MEDICAL OFFICE BUILDING

TEXAS ACCESSIBILITY STANDARDS PLAN REVIEW

Fig. 8(f)
Carpet Pile Thickness

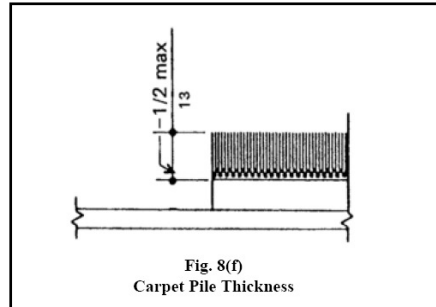
Verify Compliance, carpet complies with 4.5.3

4.5.3* Carpet. If carpet or carpet tile is used on a ground or floor surface, then it shall be securely attached; have a firm cushion, pad, or backing, or no cushion or pad; and have a level loop, textured loop, level cut pile, or level cut/uncut pile texture. The maximum pile thickness shall be 1/2 in (13

mm) (see Fig. 8(f)). Exposed edges of carpet shall be fastened to floor surfaces and have trim along the entire length of the exposed edge. Carpet edge trim shall comply with 4.5.2.

Fig. 25 b

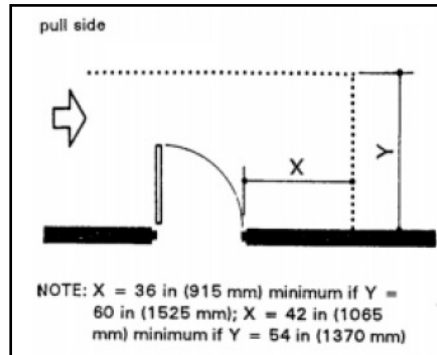
Does Not Comply, Door D48 does not have the minimum maneuvering clearance at the sidewalk (See Fig 25b).

Does Not Comply, Door D02 and D03 do not have the minimum maneuvering clearance (See Fig 25b).

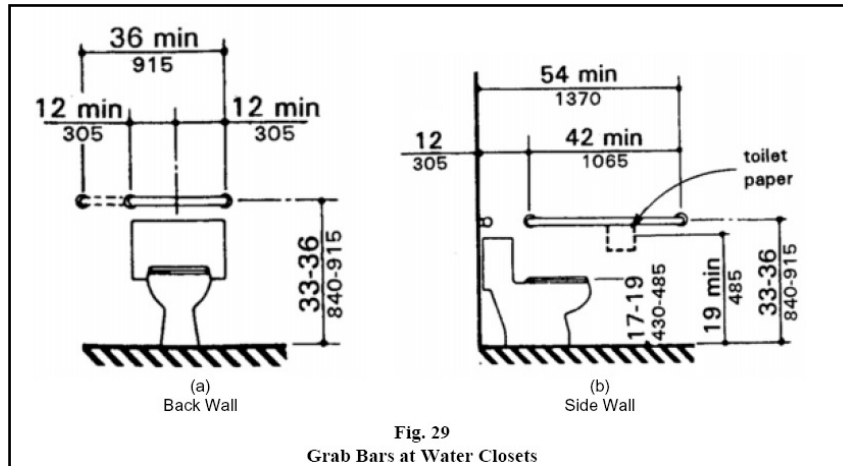
Verify Compliance, Women's Toilet 102, Men's Toilet 103, Patient Toilet 106, 113 distance from wall to grab bar, (Fig 29) is not shown on the drawings .

Does Not Comply, at all water closets. Toilet paper dispenser shall be 19" AFF (Fig 29) to centerline of dispenser.

Verify Compliance, Men's Dressing 132, Women's Dressing 133, distance from wall to grab bar (Fig. 29) is not shown on the drawings.

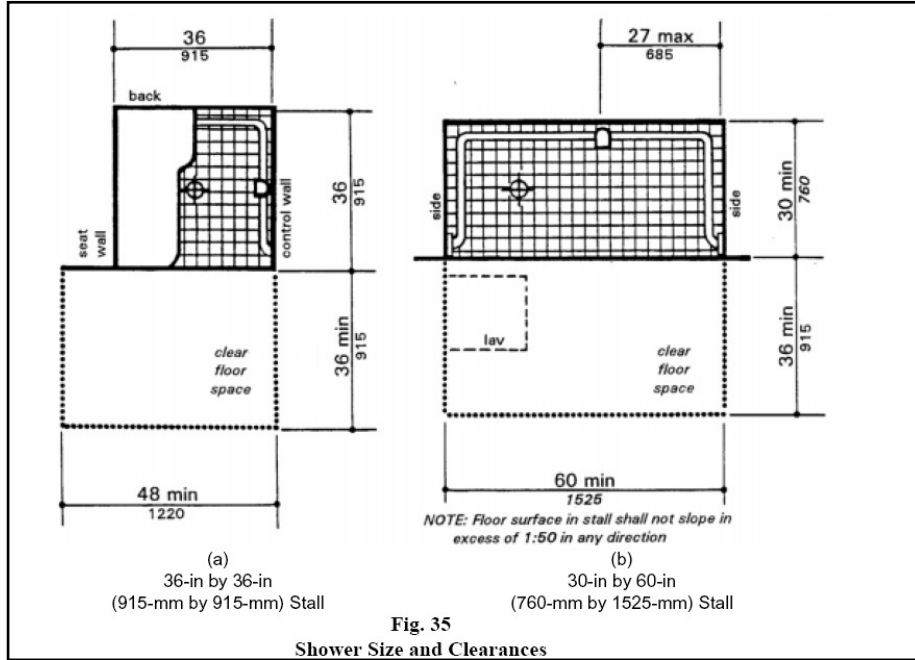
Does Not Comply, (Interior Elevation 25/A7.1), "Urinals shall be stall-type or wall hung with a tapered elongated rim mounted at a maximum of 17 in."

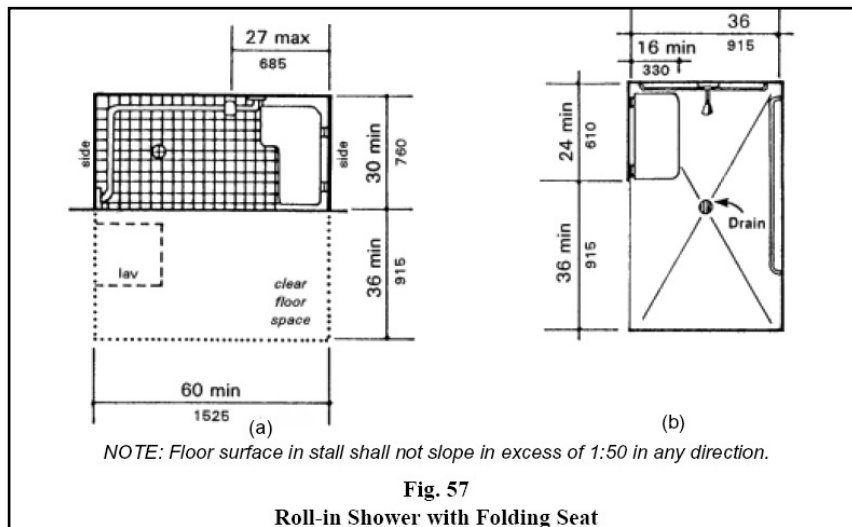
Does Not Comply, shower stall size does comply (Fig 35).

Does Not Comply, "Where a fixed seat is provided in a 30 in by 60 in minimum shower stall, it shall be a folding type and shall be mounted on the wall adjacent to the controls as shown on Fig 57. . . ."

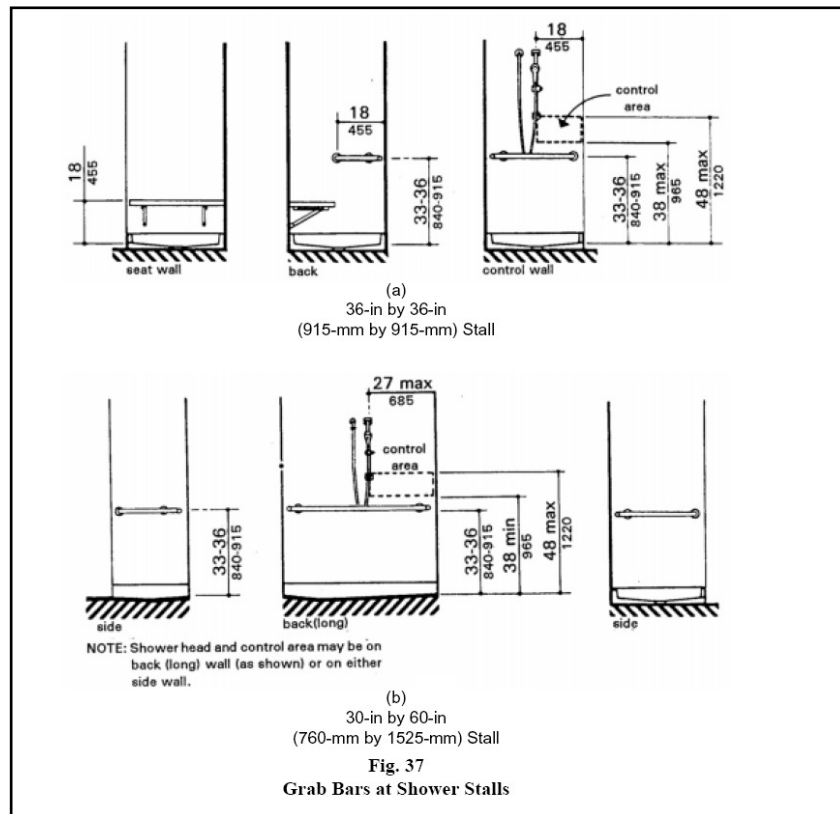
Does Not Comply, "Grab bars complying with 4.26 shall be as shown in Fig. 37."

4.21.5. Controls. **Verify Compliance**, "Faucets and other controls complying with 4.27.4 shall be located as shown in fig. 37."

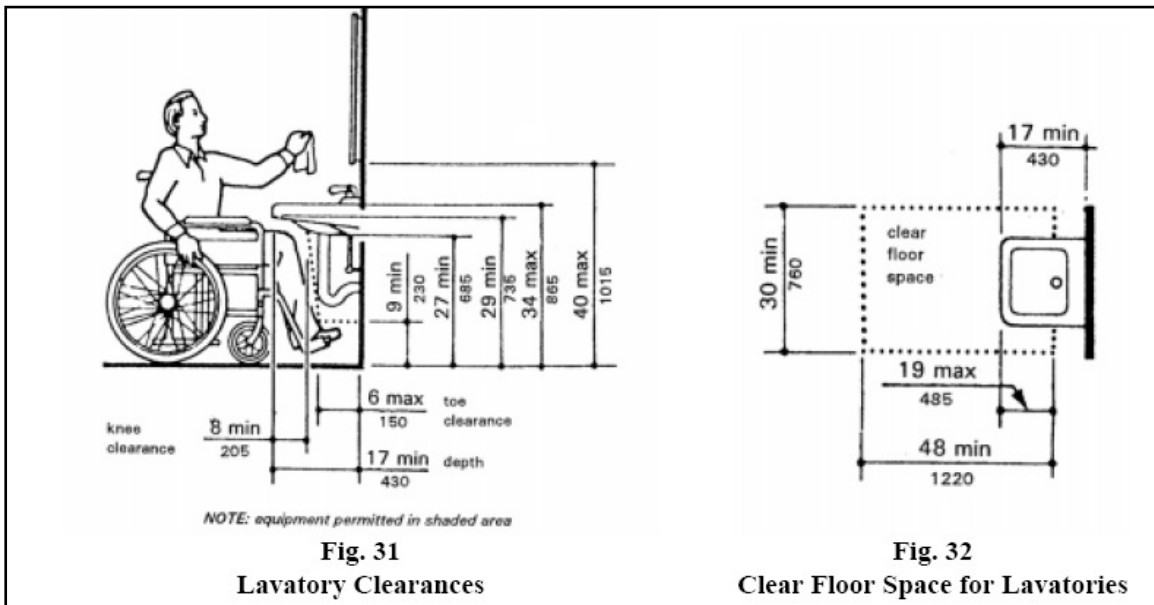
Does Not Comply, all mirror tops do not comply. *"If lavatories and mirrors are provided then at least one of each shall comply with 4.19."*

Does Not Comply, Lounge 134 (no knee space). (Fig 31,32), *"Knee clearance that is at least 27 in high, 30 in wide and 19 in deep shall be provided under sinks."*

"Mirrors shall be on accessible routes . . . shall be mounted with the bottom edge of the reflecting surface no higher than 40 in above the finished floor. Mirrors that are intended to be used by both ambulatory people and people in wheelchair users . . . must be at least 74 in high at their topmost edge."

Fig A8

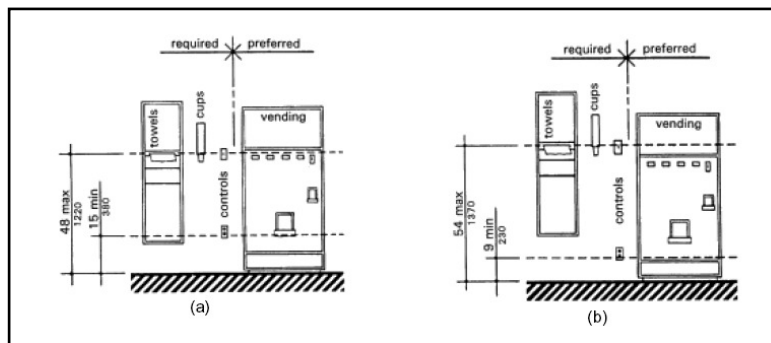
Verify Compliance, of the following controls: electrical switches, electrical outlets, fire alarm pull station, fire extinguisher, thermostats, access card readers and any controls required to be accessible by 4.1. *"Fig A8 further illustrates mandatory and advisory control mounting height provisions for typical equipment."*
